**JOINT REGIONAL PLANNING PANEL
(SOUTHERN REGION)
SUPPLEMENTARY COUNCIL ASSESSMENT REPORT 2**

Panel Reference	2017STH018
DA Number	RA17/1001
LGA	Shoalhaven City Council
Proposed Development	<p>Demolition and vegetation removal work and staged construction of a Senior Housing development comprising:</p> <ul style="list-style-type: none"> • 89 Bed Residential Care Facility (RCF) • 126 Independent living Units (ILU) (duplex and triplex forms) • 133 ILU spread over 7 x 3 storey residential flat buildings with underground car parking, • Community Centre comprising clubhouse/restaurant/medical centre/gym and swimming pool • ancillary civil infrastructure and landscaping <p>Roundabout intersection and associated civil works on Princes Highway and surrounding road reserves</p>
Street Address	<p>Lot 1 DP 780801, 276 Princes Highway, Milton Lot 1 DP 737576, Part Road Reserve Princes Highway, Milton DP U3 2224 Property ID81992, Part Road Reserve Princes Highway, Milton DP R63051603 Property ID 81999, & Part Crown Road Reserve Warden Road, Milton – Property ID 81997</p>

Report prepared by	Peter Johnston, Senior Development Planner
Report date	6 October 2020

Modelled Peak Hour Traffic Noise Levels Corrected for Seasonal Variation

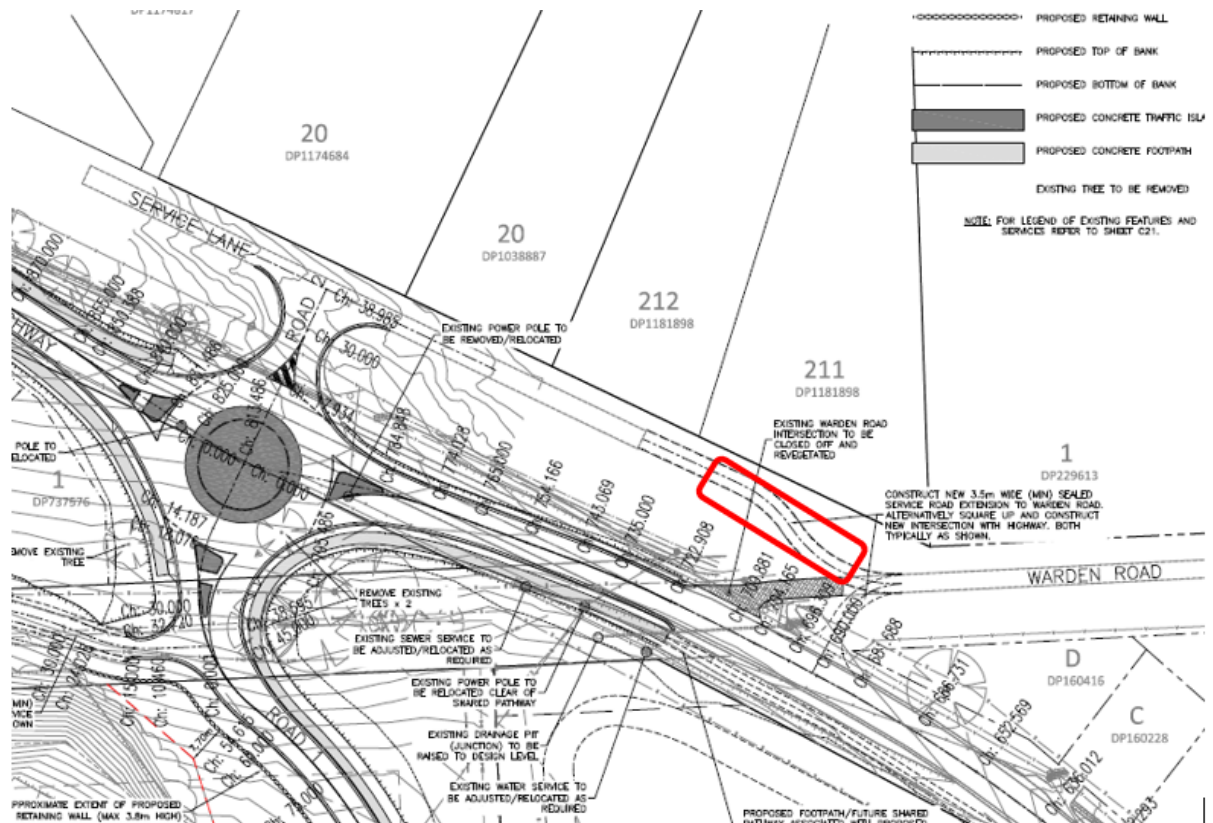
The assessment found that the proposed new roundabout and associated road works would generally result in a traffic noise level 1 dB higher than existing background noise. The maximum identified increase was found to be 2 decibels at one location identified as 267 Princes Highway which is a dwelling associated with the seniors housing development and is scheduled for demolition by the developer.

In accordance with the RNP guidance these results clarify that the proposed roundabout works do not reach the threshold for a minor impact and will be barely perceptible for surrounding residents. Given this modelled forecast, there is no justification for the provision of acoustic barrier fences or attenuation works to be provided by the developer in the highway corridor.

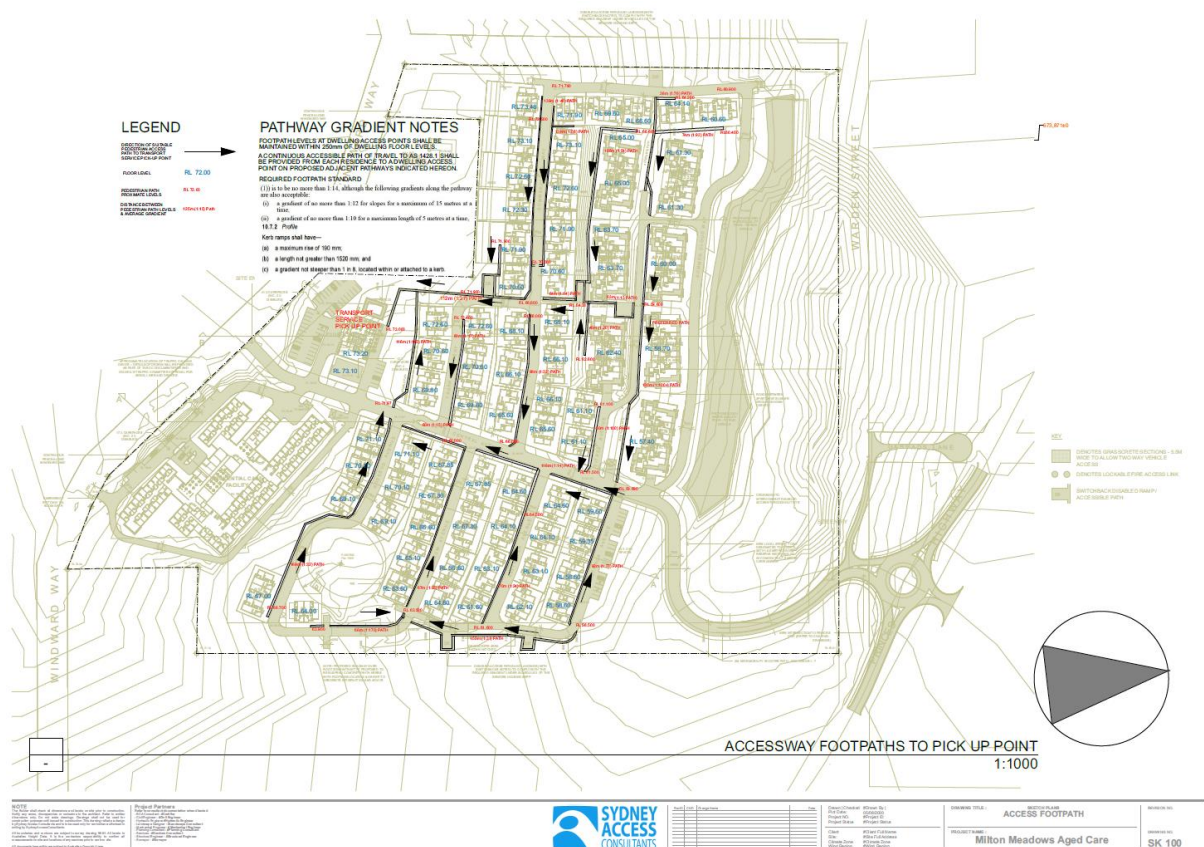
The proposed roundabout design has been carefully considered to minimise land forming impacts on the north side of the highway and hence reduced the impact on existing vegetation screen provided between the highway and the north service lane (identified as road (2) on the footprint design plans) . Existing Levels for the highway are very close to the proposed design levels for the roundabout north which further minimises land forming impacts.

The main land forming impacts associated to the roundabout relate to the south side of the roundabout and associated south arm (road 1 Central Ave) which is the main entry road into the development and road (3 Warden Road West). The south side of the highway drops away 3.7m from 60.6m AHD (centreline) down to 56.9m AHD at Chainage 0 for road 3.

Given that the main road land forming impacts are contained within the developers land and will formalise unformed Warden Road West, these impacts are considered reasonable and will provide a net public benefit of improving access to the highway while improving safety of access for pedestrians and motorists. The submitted engineering plans indicate that the fill will be battered at a suitable angle with no retaining walls proposed.

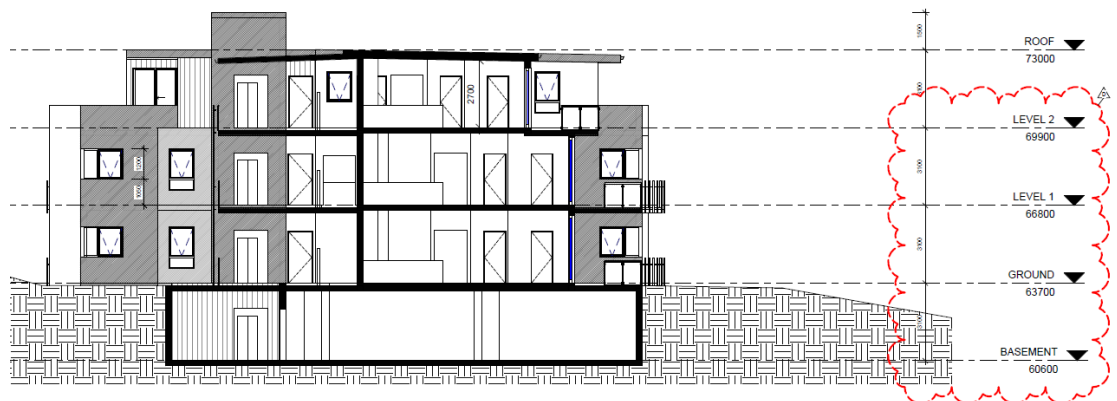
The submitted Accessway Footpath Plan and report demonstrates that all the pathway grades and distance of travel comply with clause 26 and 38 of the SEPP (Housing for Seniors) and provide access to the courtesy bus pickup/drop off location within 400m of the most distant SOU. The individual connection pathway links between the network paths described above and each SOU can easily be detailed prior to a Construction Certificate being issued.

Apartment Sections - Section AA (DA43) (D20/391610)

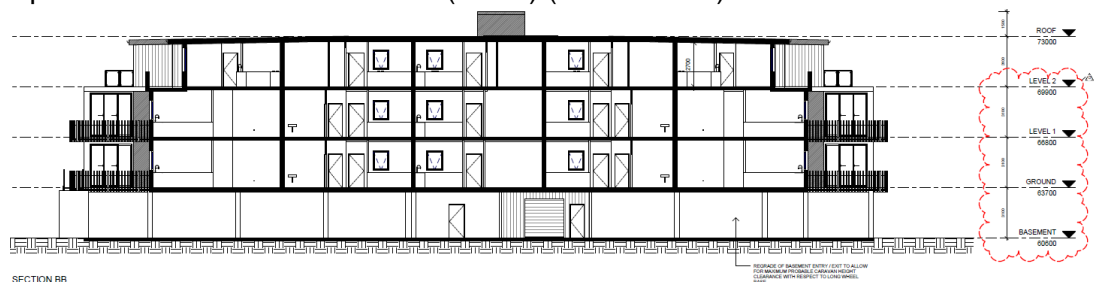
- *Increase in floor to floor heights from 2.9m to 3.1m to allow for required services and compliance with ADG. This has been achieved by lowering the building 500mm and therefore the proposed building height remains unchanged.*
- *Basement has been reduced from 3.2m to 3.1m and meets required clearances for vehicles anticipated to use the basement.*

The minimum floor to ceiling height requirements identified by the Apartment Design Guide (ADG) have now been complied with.

By excavating down an additional 500mm and reducing the basement ceiling height by 100mm to 3.1m, the net result is no change to the overall height of the apartment buildings which remain compliant with the 11m height of building plane.

Extract of Zenith Landscape plan identifies APZs (purple zone marked L)

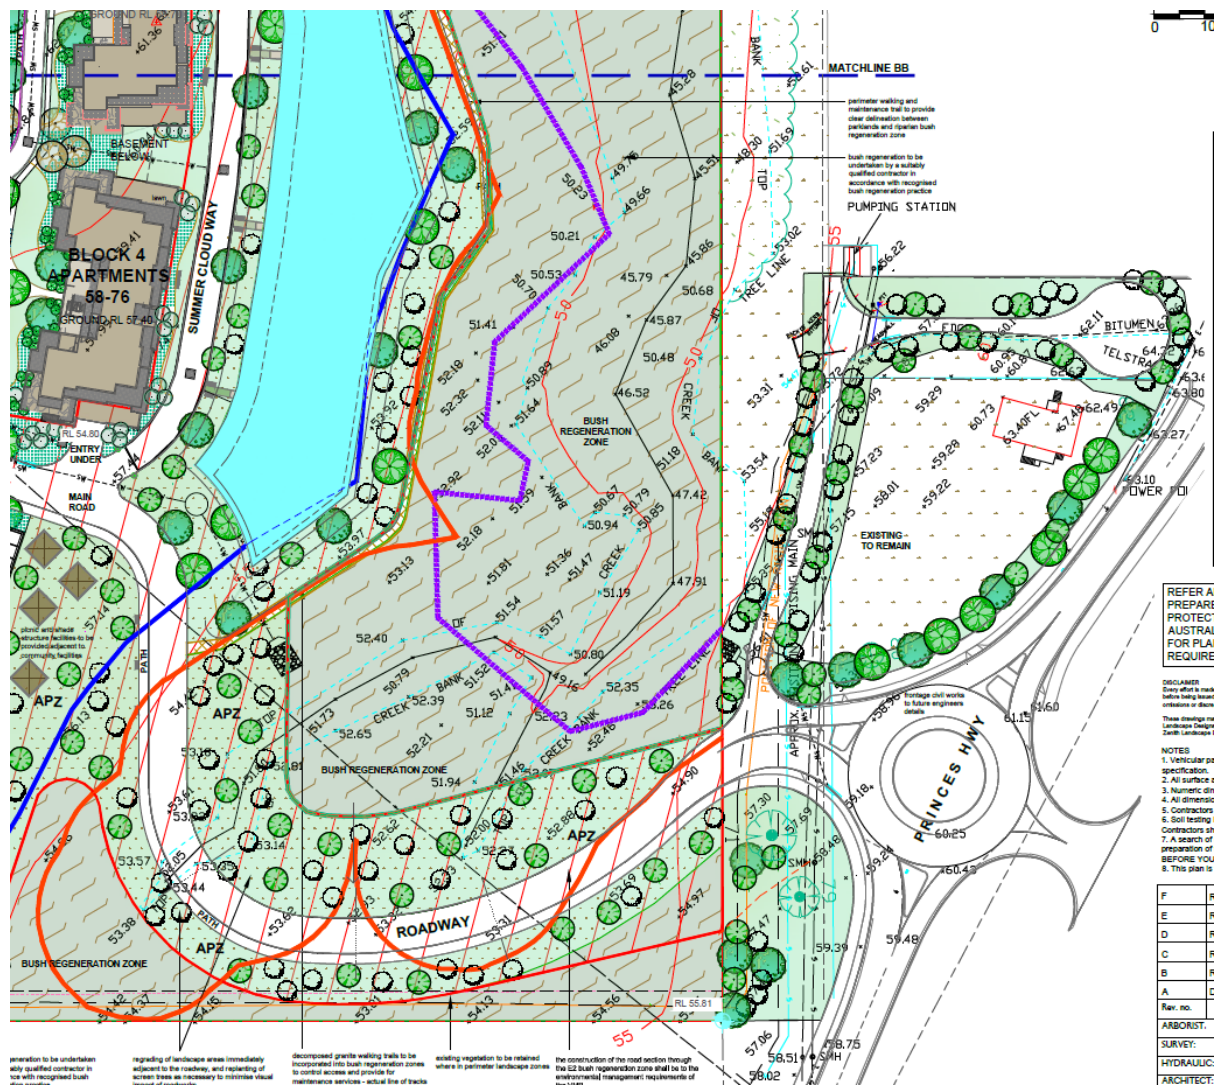
The main difference with the revised landscaping plan facing the highway is the IPA now extends 37m north from the north face of buildings along Summer Cloud Way to the bush regeneration zone (riparian zone).

While vegetation plantings within the IPA are more spaced out as individual trees to comply with the Appendix 4 of 'PBP 2019, they will retain an effective screen to the highway given proposed highway south side landscaping, the circular nature of the main entry road landscaping preventing line of sight and the existing density of riparian vegetation.

East through adjoining Caravan Park (Future MHE)

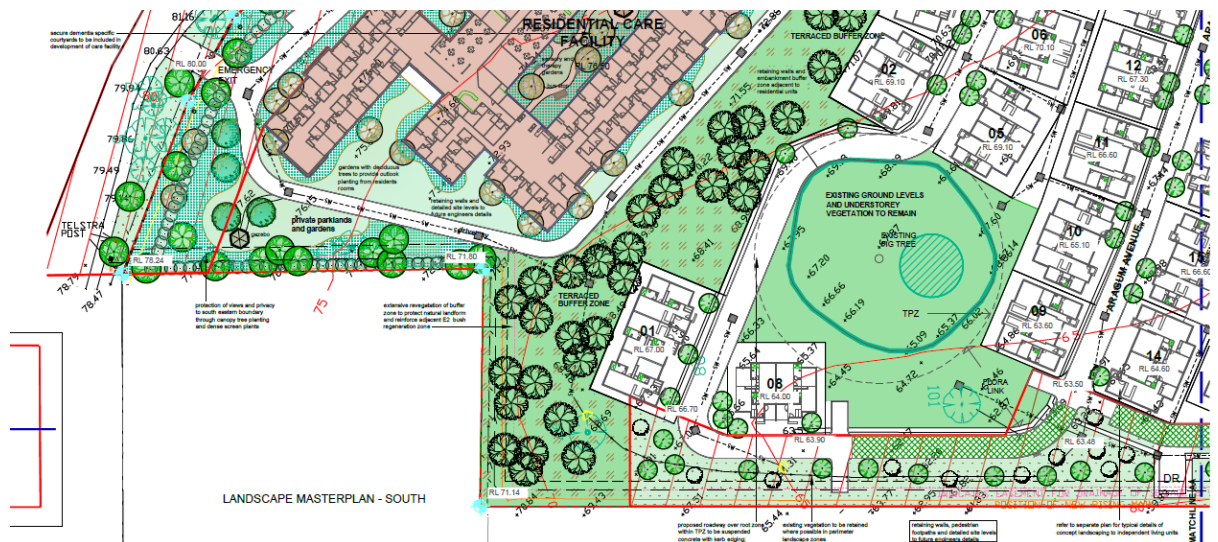
Effective screening along this boundary is difficult to achieve given the close proximity of the adjoining caravan park sites and the minimal landscaping within the caravan park. The change to landscaping along this frontage to comply with Appendix 4 of 'PBP 2019, consists of spacing trees more individually than the previous clumped grouping design that will provide a more filtered view between the properties.

West adjacent unnamed Road Reserve

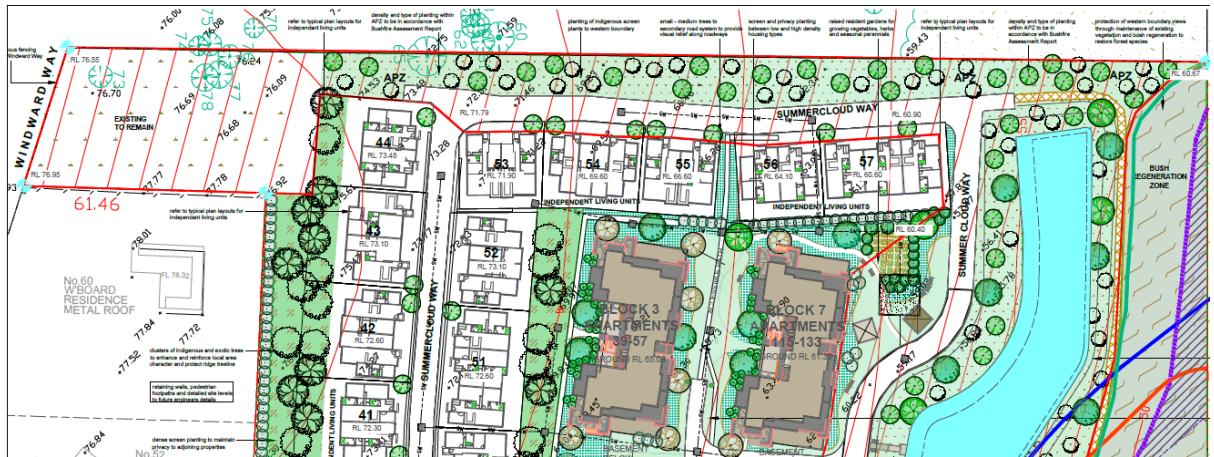
The change to landscaping along this frontage to comply with Appendix 4 of 'PBP 2019, consists of spacing trees more individually and in a staggered arrangement than the previous clumped and spaced design that will provide a more continuous screen.

To minimise visibility of built form adjacent this boundary, the first row of buildings are all setback 20m and comprise single storey SOUs. The multistorey apartment buildings are setback approximately 45-47m from the western boundary and are nestled into the lower slope to minimise their potential visual impact to this boundary.
